September 13, 2021

Pearl High School Indoor Training Facility
Pearl, Mississippi

ADDENDUM NO. 03

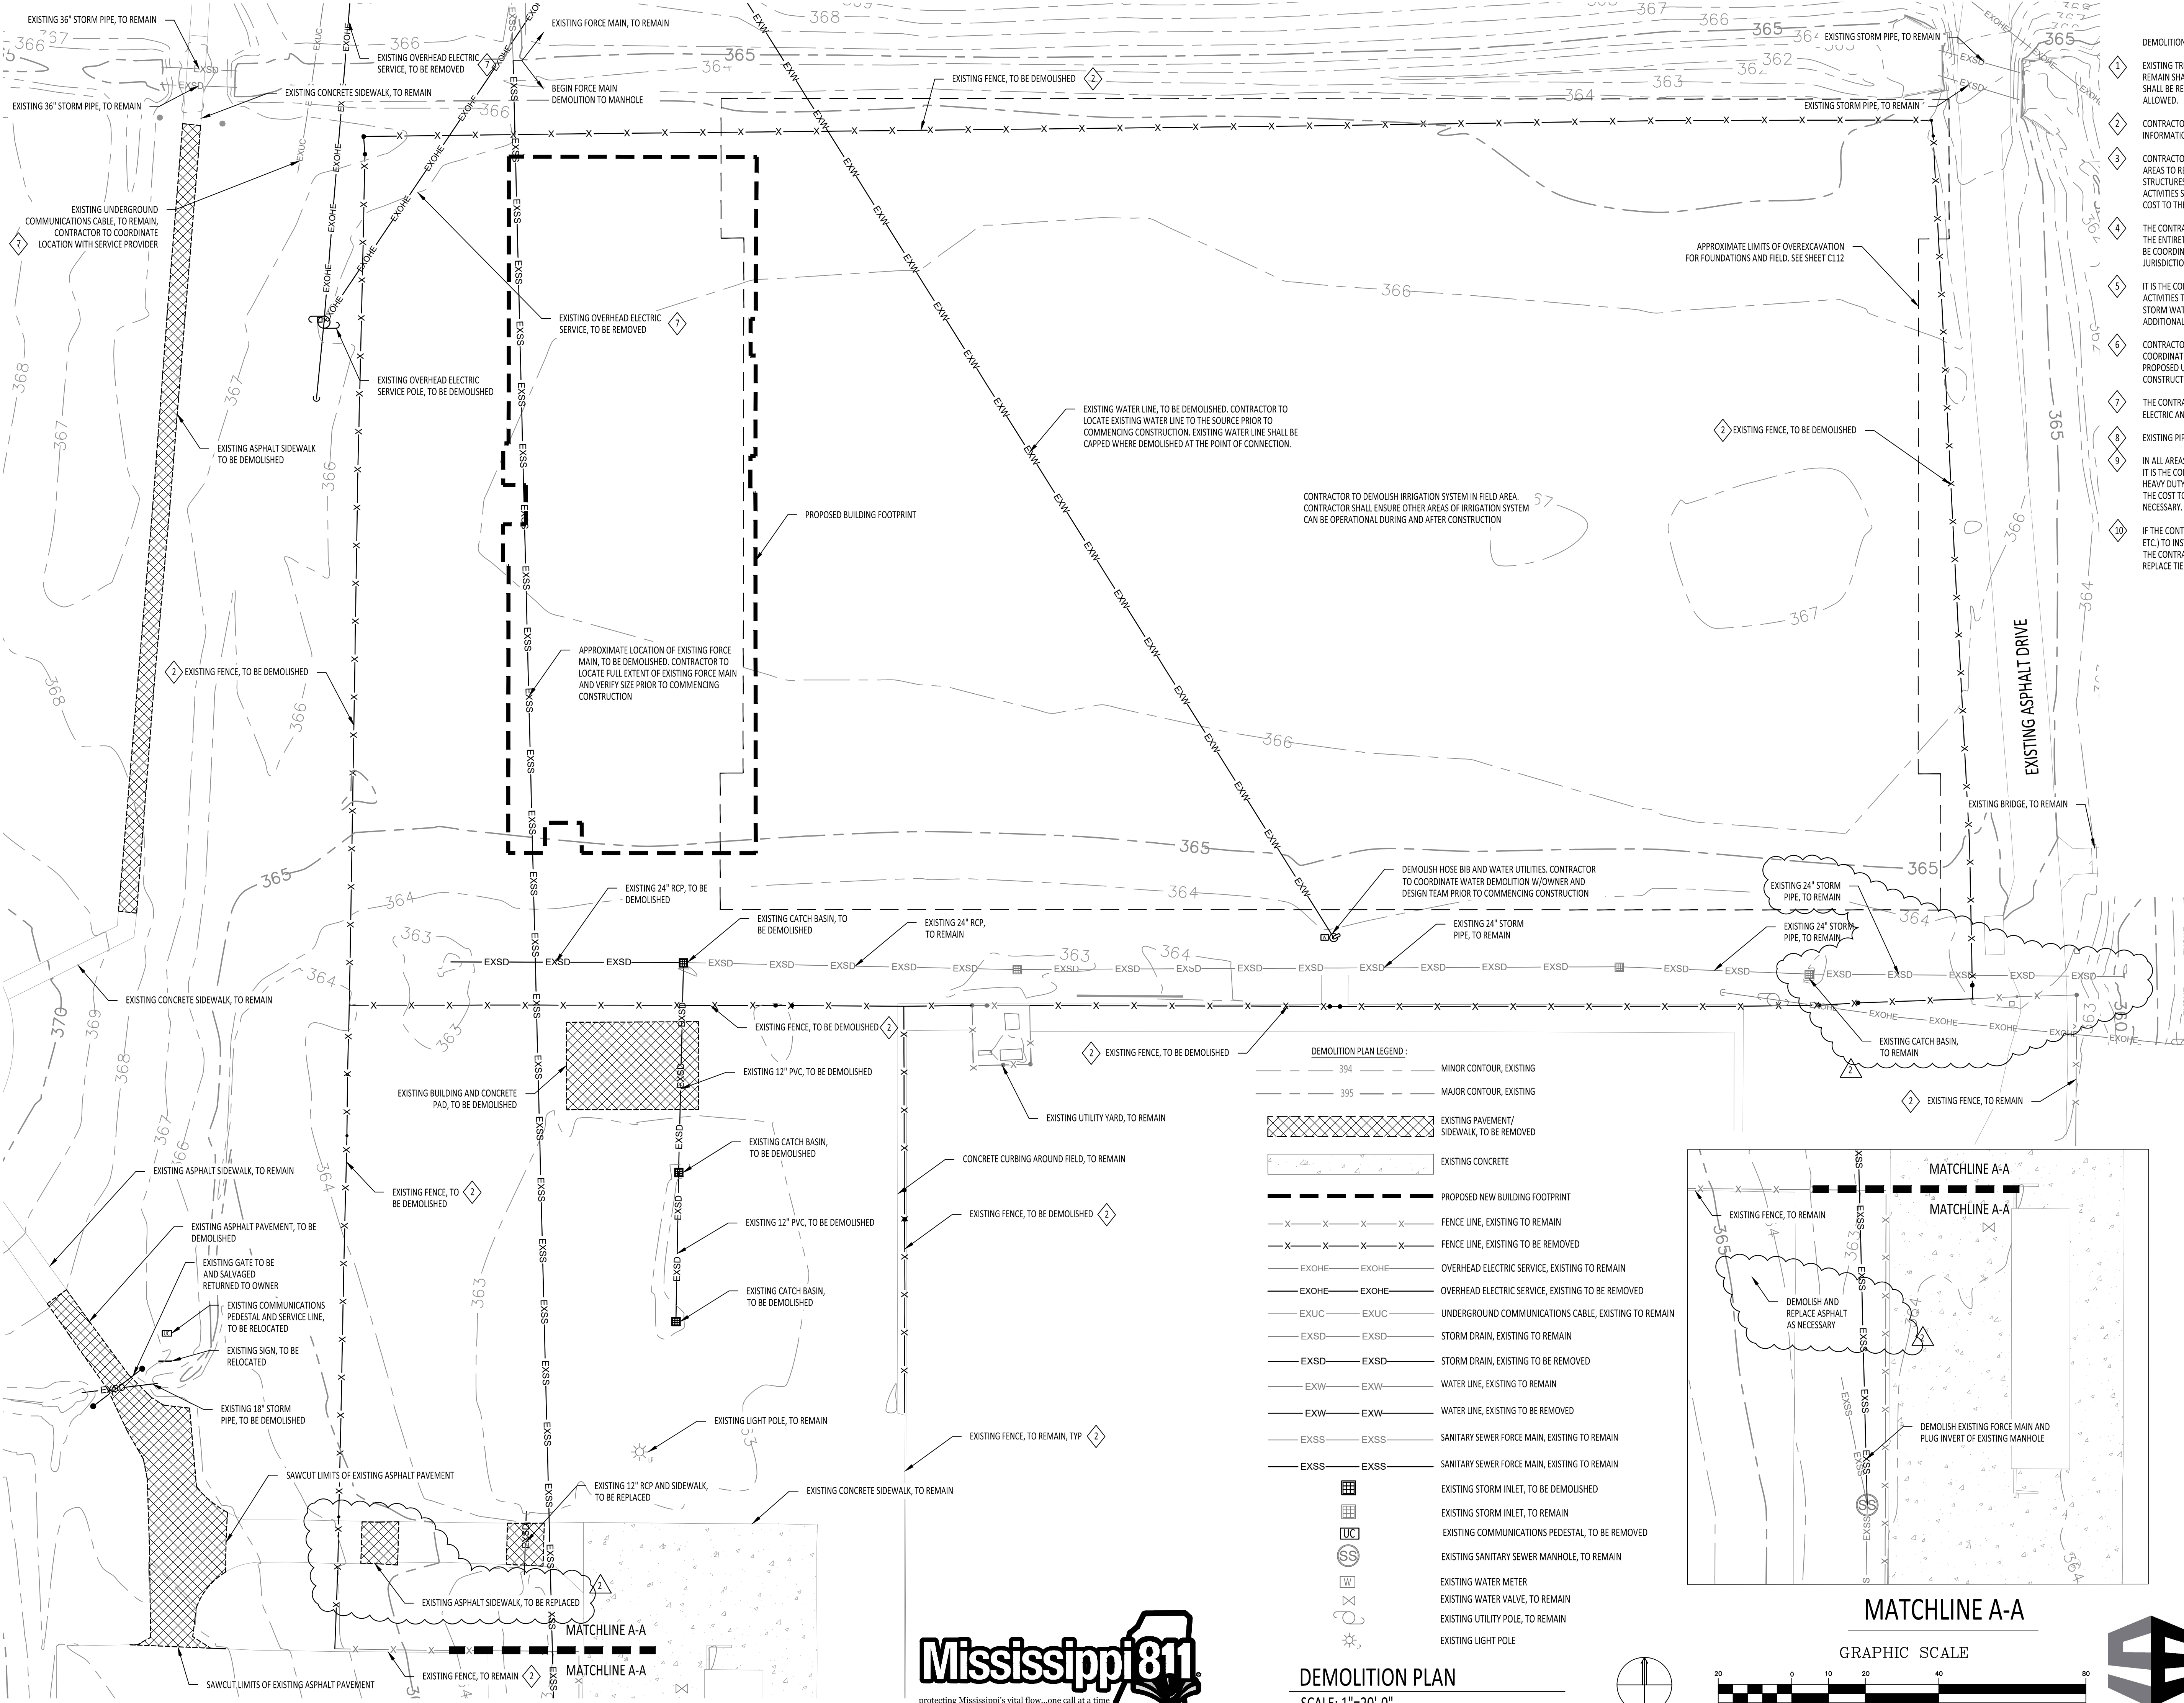
ITEM NO. 03 A102 FIELD HOUSE PLAN

Add the following **General Note** to Rooms Assistant 104 & Assistant 106:

"Provide millwork counter on three sides of room as indicated by floor plan. Counter shall be 2'-0" deep w/ cont. 4" backsplash". Finish Shall be Plastic Laminate. Brackets shall be heavy duty steel type spaced @ 2'-0" o.c. max. typical."

Add the following **General Note** to this Sheet:

"The following items shall be Owner-Purchased and Contractor-Installed:

Training Tables at Trainer 116

Walk in Cooler and Freezer units at Concessions 127

Commercial Food Service Equipment at Concessions 127

Ice Maker at Storage 124

Compact Shelving Storage System at Storage 124"

DEMOLITION PLAN
SCALE: 1"=20'-0"

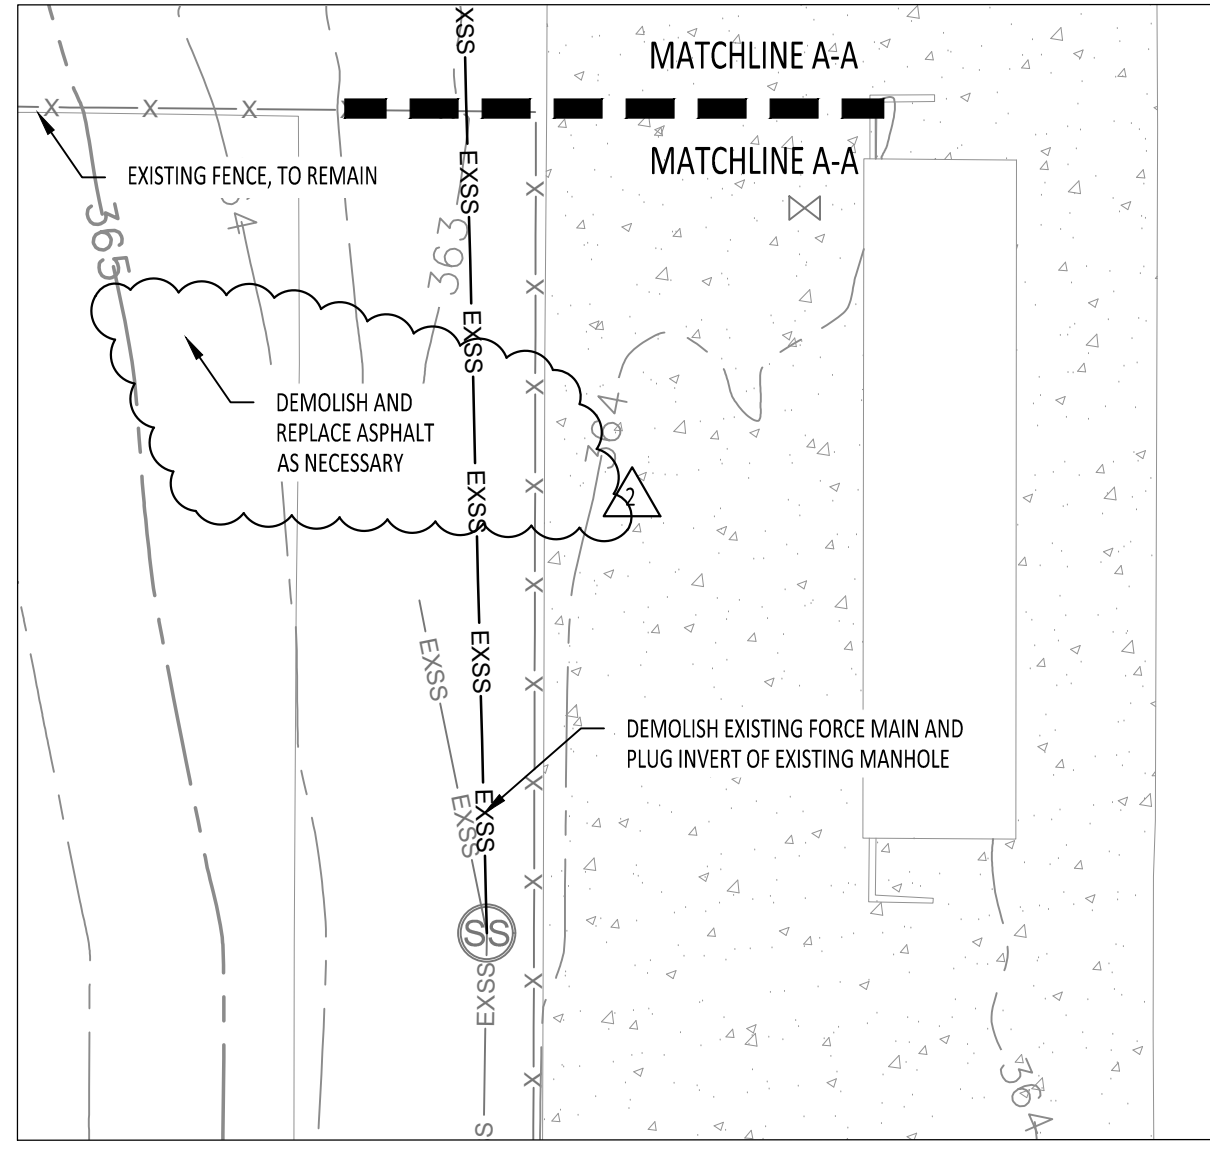
ITEM NO. 02 C111 DEMOLITION PLAN

Revise per the enclosed sheets

GRADING PLAN
SCALE: 1"=20'-0"

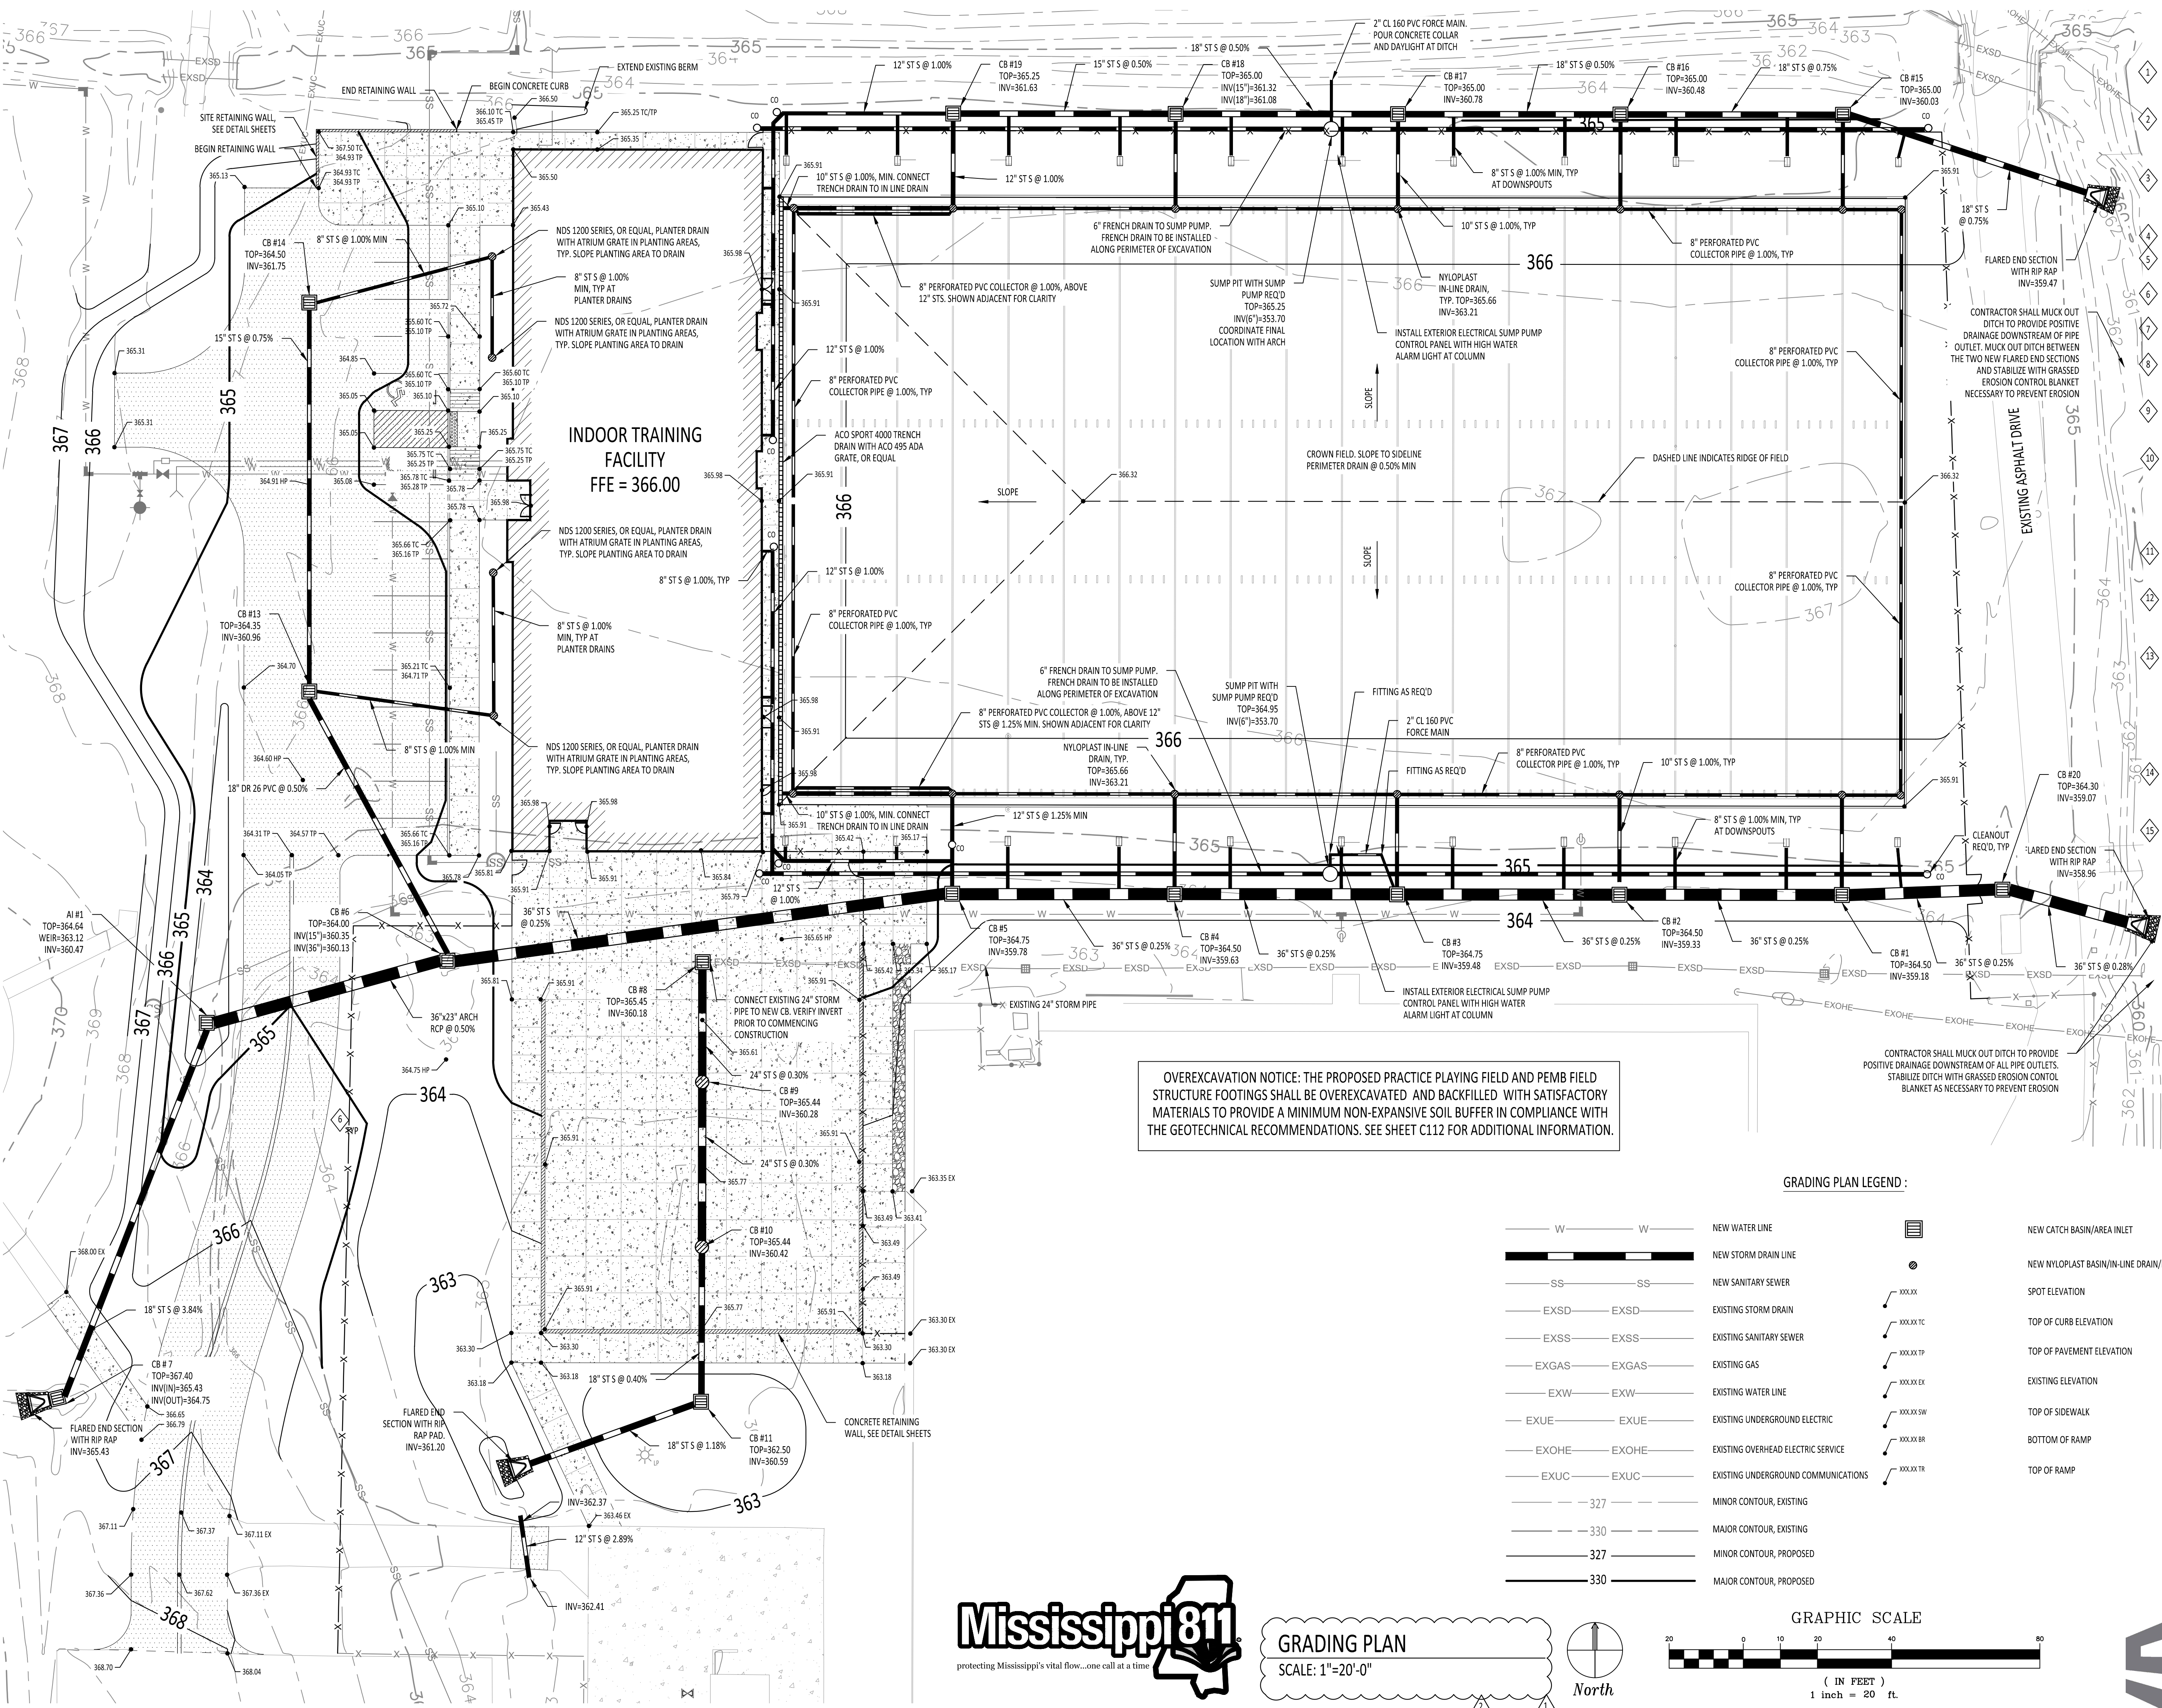
C131 GRADING PLAN
